# PRODUCT BULLETIN

**Bulletin No:** PB381

Change to N51-01, N51-05, N51-06

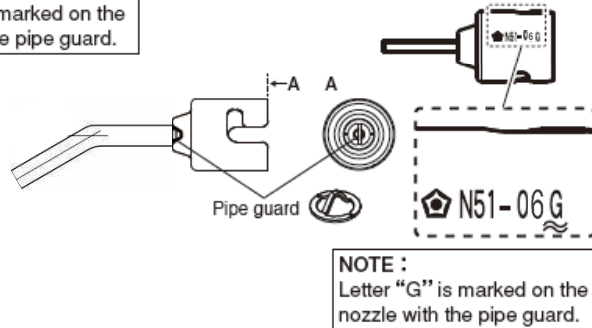
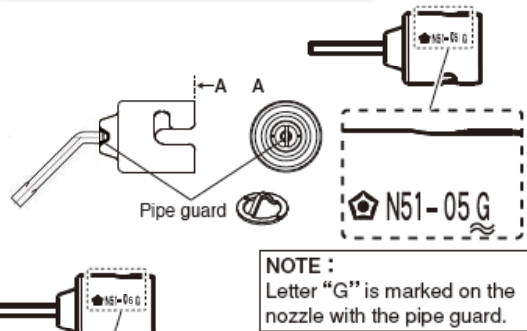
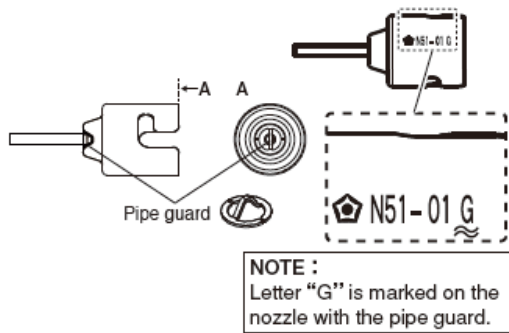
The N51-01, N51-05 and N51-06 nozzles have changed with an upgraded pipe guard that will prevent the use of the vacuum pickup and will prevent damage to the unit. The new nozzles will be denoted on the outside of the nozzle by a "G" following the part number.

**Note: If using an older N51-01, N51-05 or N51-06 without a "G" denoted on the outside of the nozzle, do not use the vacuum pickup feature as you can cause damage to your unit. Please refer to PB378 FR-810B Hot Air Rework Station and the FR-810B User Manual, Section 4 for more information.**
